DEVELOPMENT APPLICATION ASSESSMENT REPORT

Application Number:	DA2019/1522
----------------------------	-------------

Responsible Officer:	Anne-Marie Young
Land to be developed (Address):	Lot 2 DP 7391, 43 Beach Road COLLAROY NSW 2097 Lot 1 DP 300846, 41 Beach Road COLLAROY NSW 2097
Proposed Development:	Consolidation of two lots into one, demolition works and construction of a dwelling house including a swimming pool
Zoning:	Warringah LEP2011 - Land zoned R2 Low Density Residential Warringah LEP2011 - Land zoned R2 Low Density Residential
Development Permissible:	Yes
Existing Use Rights:	No
Consent Authority:	Northern Beaches Council
Delegation Level:	NBLPP
Land and Environment Court Action:	No
Owner:	Russell Forester Staley Jennifer Susan Staley
Applicant:	Virginia Kerridge Architect

Fig.1 Extract from Survey Plan showing existing dwelling and levels
adjacent to Tree 13

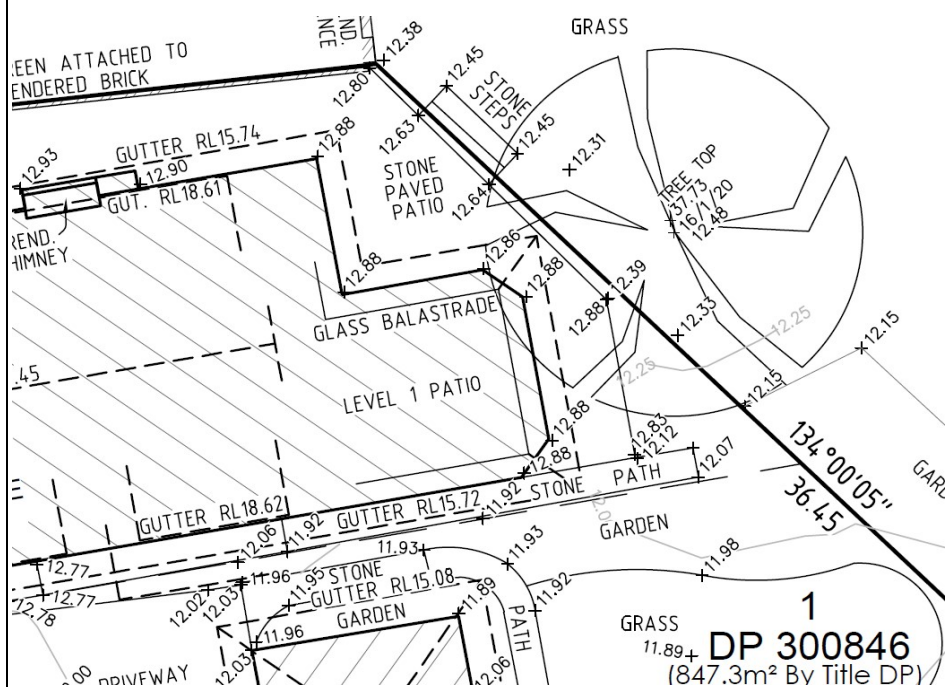
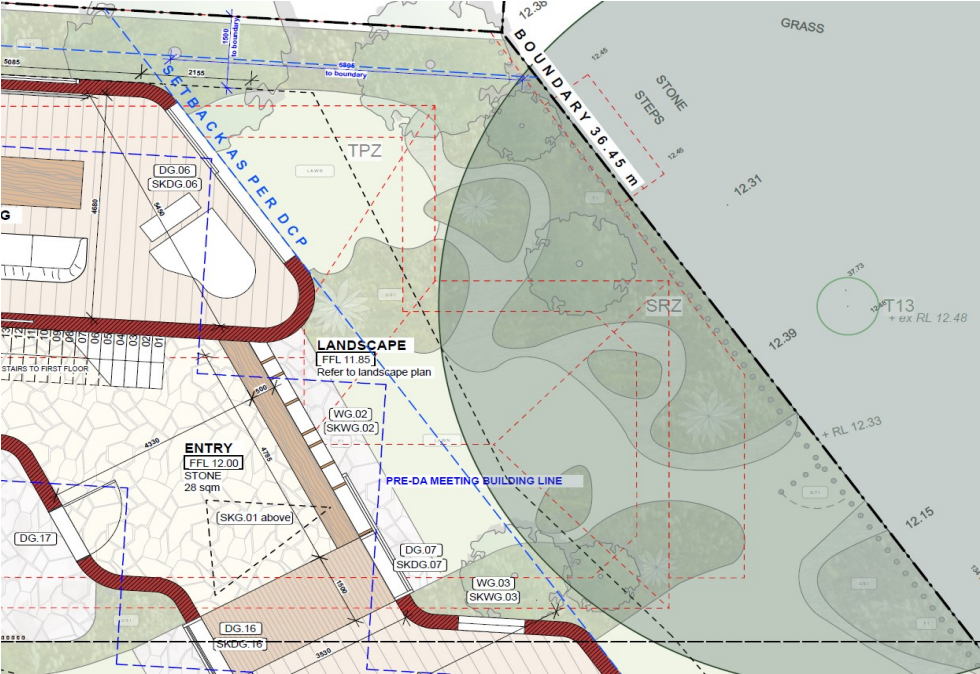
Internal Referral Body	Comments
Landscape Officer	<p>The Arborist's Report indicates that 5 trees are to be removed to accommodate the proposed works (Trees 2, 3, 6, 7 and 11). The Tree Protection and Removal Plan in the Landscape drawing package indicates one additional tree (Tree 5) to be removed.</p> <p>In assessing the trees to be removed, it is apparent that Tree 7 is located on the adjoining property at No. 45 Beach Road. As such, approval to remove cannot be granted without the owner's consent which hasn't been sighted.</p> <p>Tree 2 is located within the road reserve and will be affected by the new driveway crossover. As it is a relatively young tree and adjacent to electricity wires, no objections are raised to its removal.</p> <p>Tree 5 is located within the proposed front private open space area and is being removed to enable an open grassed setting surrounded by gardens. The tree is relatively young and no objections are raised to its removal in consideration of the compensatory tree planting proposed in the Landscape Plans.</p> <p>The Landscape Plans indicate graphically the planting of 16 trees around</p>

Internal Referral Body	Comments
	<p>the property. This is supported to replace the canopy removed for development.</p> <p>Two significant trees are located in the public reserve to the east of the development, close to the boundary. Trees 12 and 13 are mature <i>Araucaria heterophylla</i> (Norfolk Island Pines).</p> <p>The plans indicate that works will occur within the Tree Protection Zone (TPZ) of both the trees. The impacts on Tree 12 are relatively minor and can be accommodated with supervision of a Project Arborist and the tree protection recommendations in the Arborist's Report.</p> <p>The impacts on Tree 13 are more significant with works proposed within the theoretical Structural Root Zone (SRZ) of the tree.</p> <p>Whilst the basement level has been designed to be setback from the tree, it is evident from the Architectural, Landscape and Stormwater Plans that excavation is proposed at ground level within a significant portion of the tree's TPZ and SRZ.</p> <p>It is recognised that the existing dwelling is located very close to Tree 13, however comparison of existing levels and proposed levels indicates that the new level in the rear yard will be approximately 800mm below the existing levels.</p> <p>Photo 1 below indicates the relationship between the existing dwelling and Tree 13. It is recognised that the levels shown on the Survey Plan (Fig. 1 below) are raised. Excavation below the level of the existing terraces will however still be required to achieve the levels proposed on the plans provided.</p> <p>This is considered to be a significant impact on the TPZ and SRZ of Tree 13.</p> <p>In order to minimise the impacts on the tree to an acceptable level, it is recommended that the ground levels immediately below the terraces and existing dwelling within the TPZ of Tree 13 be maintained and any reshaping of the landform to provide for water diversion and marrying-in to new floor levels occurs outside of the TPZ of Tree 13. This would be still be required to be undertaken under the supervision of the Project Arborist and responding on site to the below ground conditions once the terraces and existing building have been removed.</p> <p>Recommended conditions have been included addressing the issues raised above.</p> <p>Subject to the conditions as recommended, no objections are raised approval with regard to landscape issues.</p>

Extract / analysis from survey showing point J2

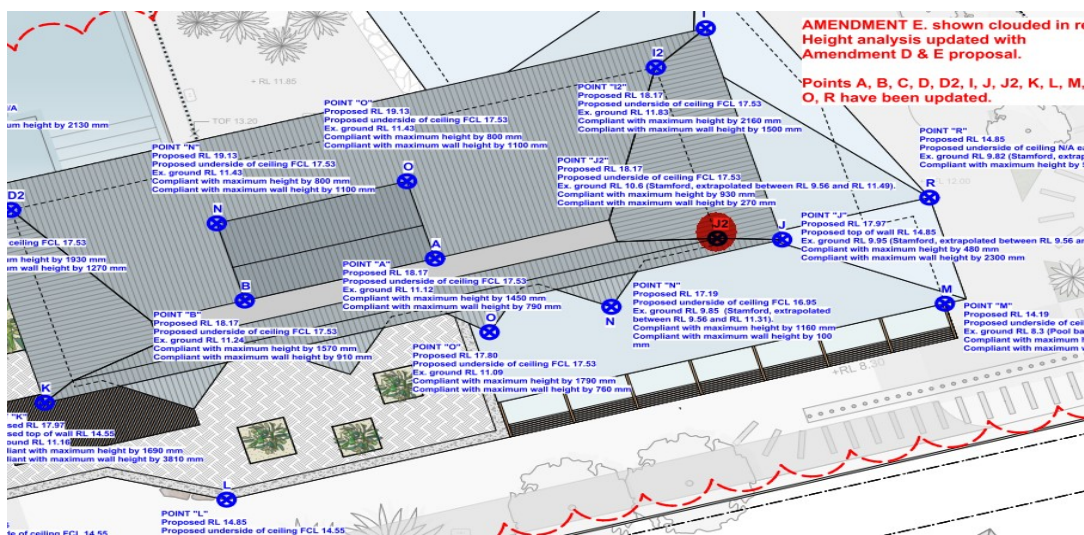
Point J2 is located approximately 1.7 m to the north of the pool paved area. It is noted that the pool paved area has been surveyed at RL 9.56 which is the level which the objectors suggest should be applied as the existing ground level at point J2. Refer to images below.

Point J2 located approximately 1.7 m north of the pool deck / platform RL 9.56.

Southern elevation showing the breach of the side envelope.

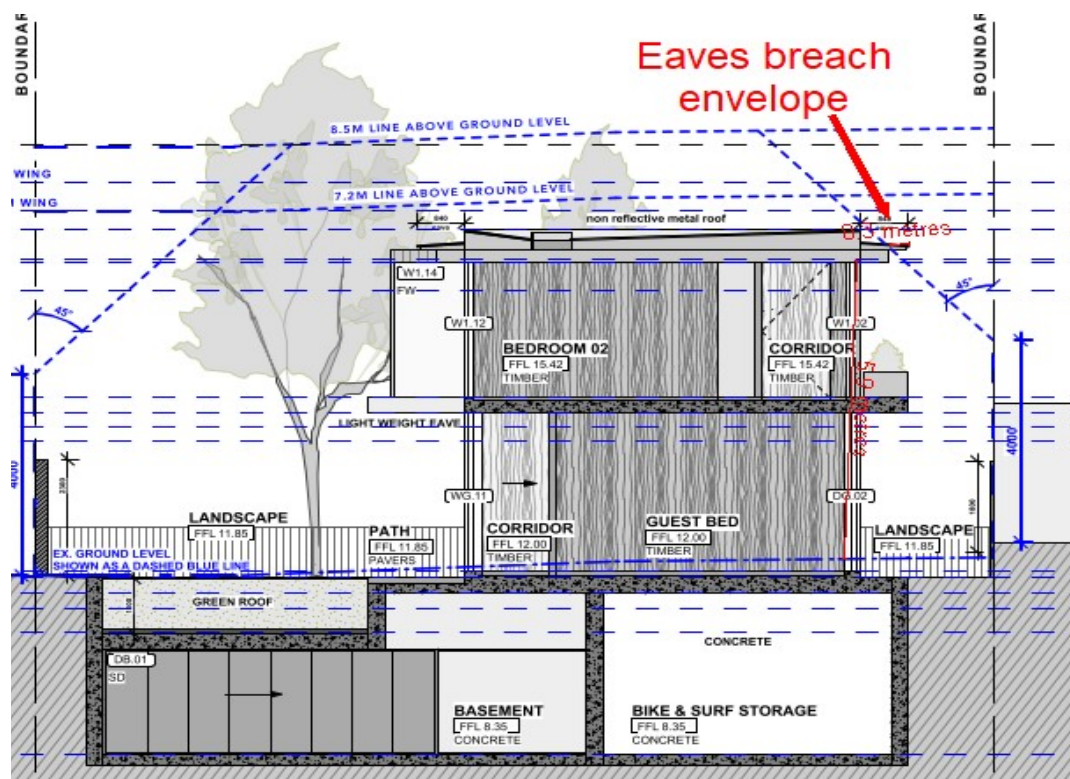
- 0 - 0.5 m breach in height for a length of 2.1 m which relates to the south east edge of the roof over the deck to the first floor master bedroom.
- 0 - 0.6m breach in height for a length of 3.9 m which relates to the eaves above the ground floor WC.
- 0.3 m breach in height for a length of 32 m which relates to the eaves of the northern pavilion on the northern elevation. Refer to images below.

Northern pavilion - eaves breach envelope

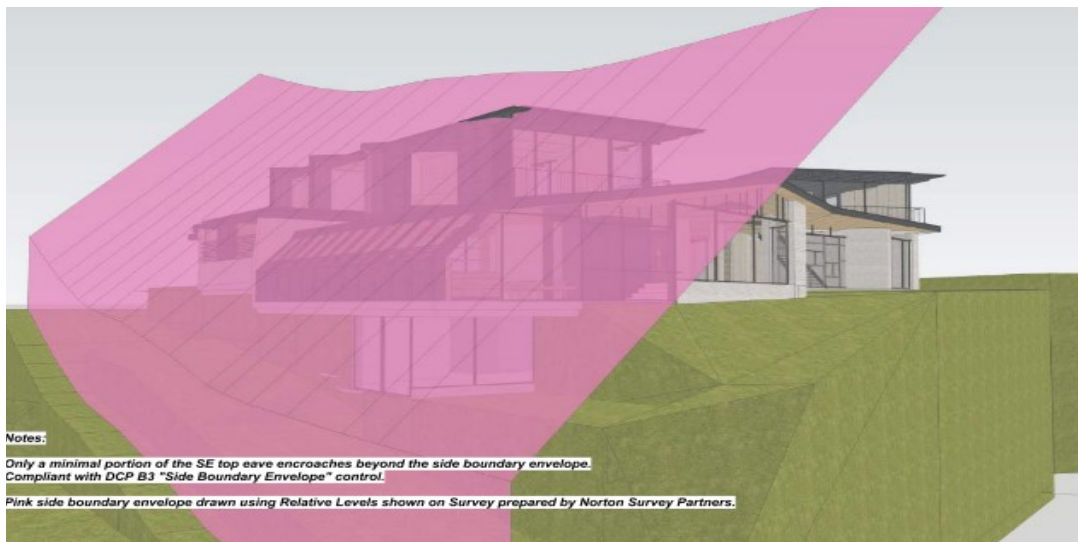
As a result of the modifications the amended proposal generally complies with the side envelope control with the exception of three minor breaches, namely:

Part of the first floor plan to the northern pavilion showing the windows and deck which are required to have fixed louvres installed.

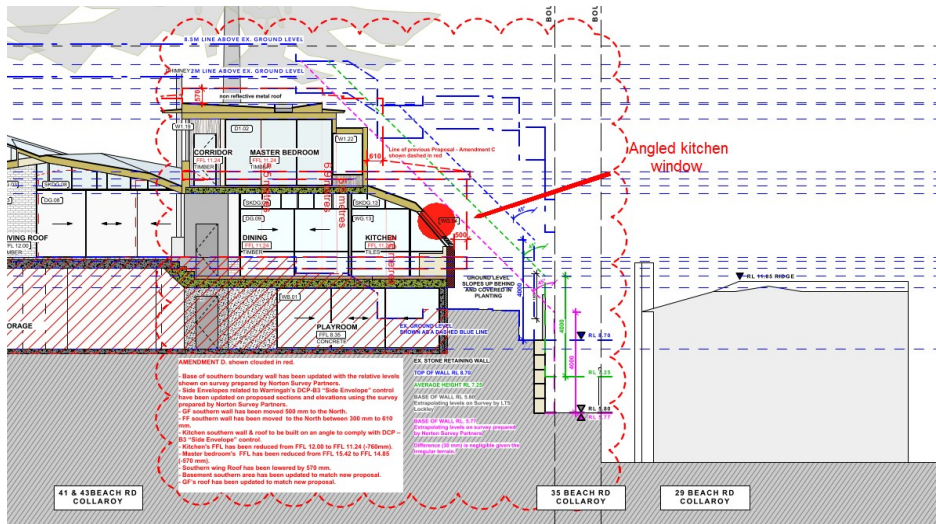
The upper floor windows of the northern pavilion are set back 2.3m from the northern boundary. The windows relate to a corridor (non-habitable space), a bedroom and a lounge room. In addition, decks adjoins the bedroom and lounge. Privacy devices are used in the design including a splayed window to the lounge with the glazing at an oblique angle, planter beds adjacent to the bedroom windows and the window to the corridor and privacy screens to the northern edge of the decks. Given the location of the windows in the southern elevation of No. 45 Beach Road to the immediate north a condition requires privacy screens to be installed on the north facing bedroom windows reference W1.01, the lounge window reference W1.28 and the entire northern edge of the decks, refer to image below. It is noted that the existing dwelling at No 41 Beach Road is setback between 2 m and 2.9 m from the northern boundary with first floor windows directly overlooking No. 45 Beach Road. Subject to the recommended conditions it is considered that the proposal has the potential to enhance the privacy to the neighbouring northern property at No. 45 Beach Road.

Existing sandstone retaining wall on the southern boundary.

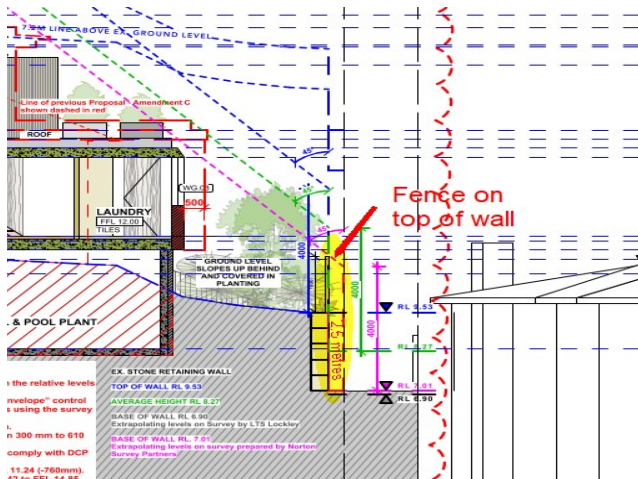
As discussed elsewhere in this report there is a significant level difference of approximately 3 m to the south side boundary of the site. A sandstone retaining wall has been constructed along the edge of the southern boundary which varies in height from approximately 2 m to 3 m. The original proposal included a 1.8 m high timber fence on top of the sandstone wall which has raised concerns from neighbours relating to the visual and solar access impacts associated with the proposed boundary treatment.

In order to address these concerns the design of the fence has been amended to a 1.2 m high see through / open safety fence comprising fine 16 mm steel vertical rods spaces 100 mm apart refer to image below. The proposed fence will provide for safety while ensure minimal adverse visual and amenity (solar access) impacts to the southern neighbour.
